CITY PLAN COMMISSION

FILE NUMBER: Z212-218(JA) **DATE FILED:** March 15, 2022

REQUEST: An application for a Planned Development District for a public school other than an open enrollment charter school on property zoned an R-7.5(A) Single Family District.

STAFF RECOMMENDATION: **Approval**, subject to a revised development plan, a traffic management plan, a revised landscape plan, and staff's recommended conditions.

L2.01

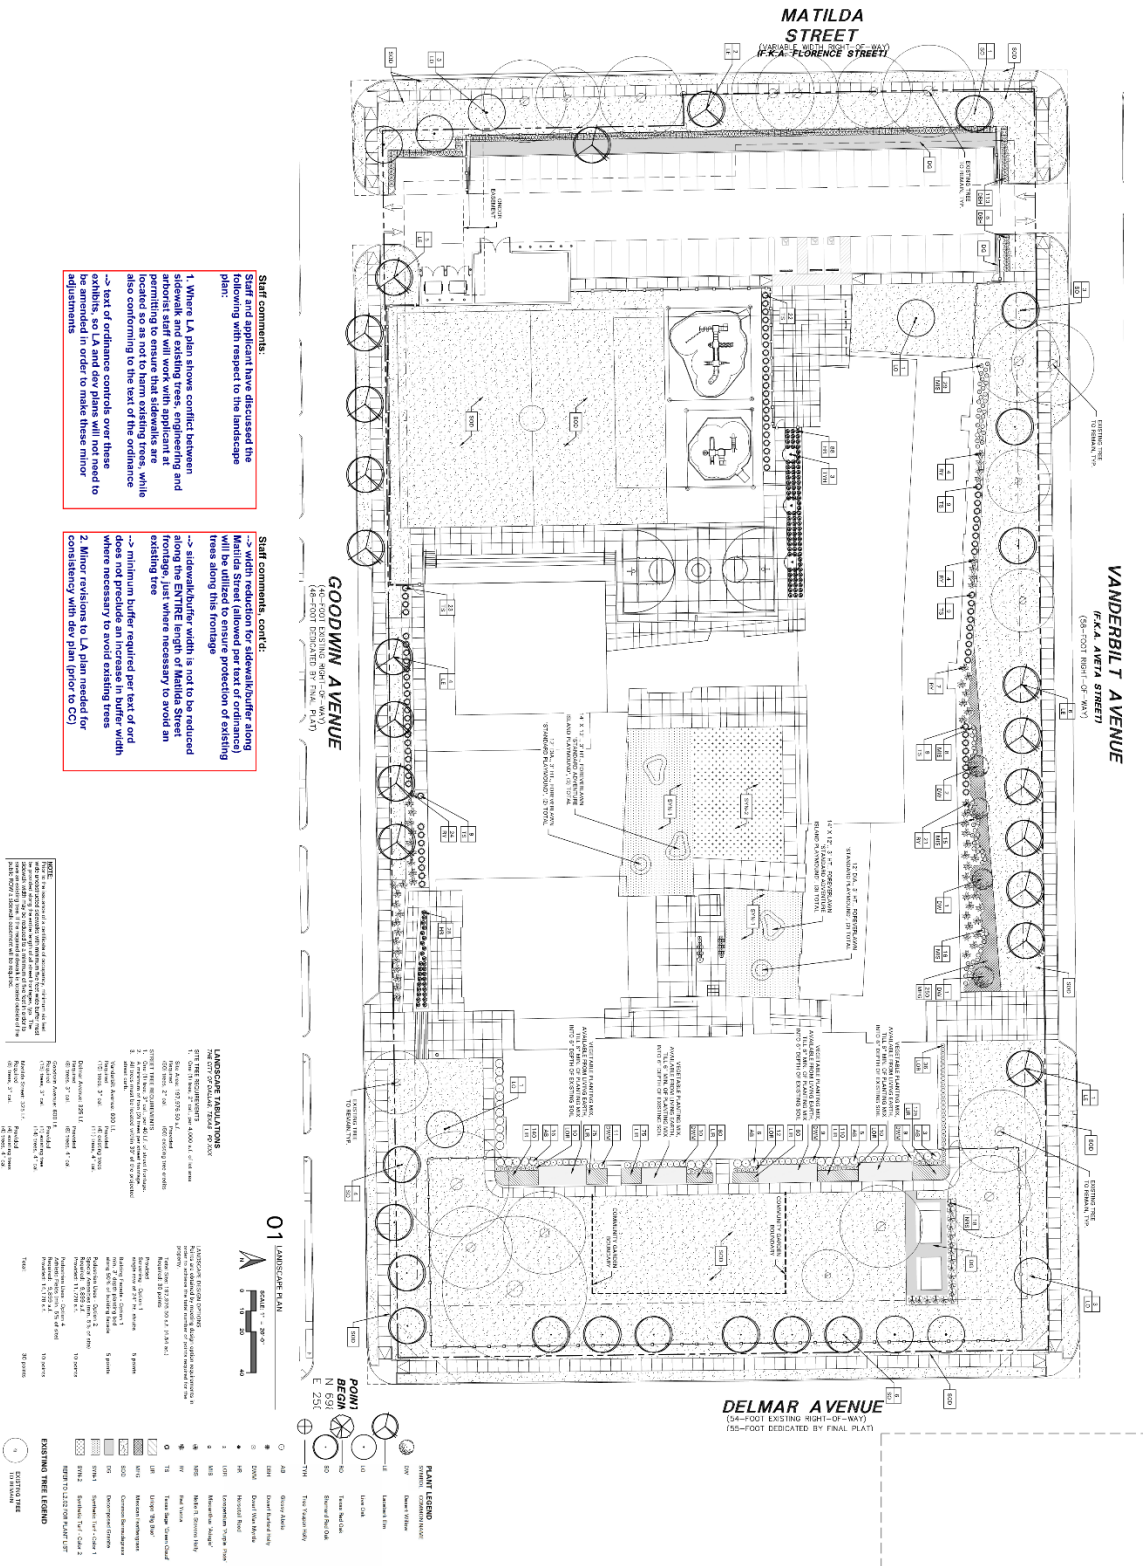
Except as noted in proposed Sec. 51P-xxx.111, landscaping must be provided in accordance with Article X of the Dallas Development Code. As a condition of the PD, a landscape plan that complies with Article X must be approved by the city plan commission prior to submitting for a building permit. Proposed Exhibit C_Landscape Plan is included in the docket and is recommended for approval by the city arborist, subject to staff comments noted on the proposed landscape plan shown later in this staff report.
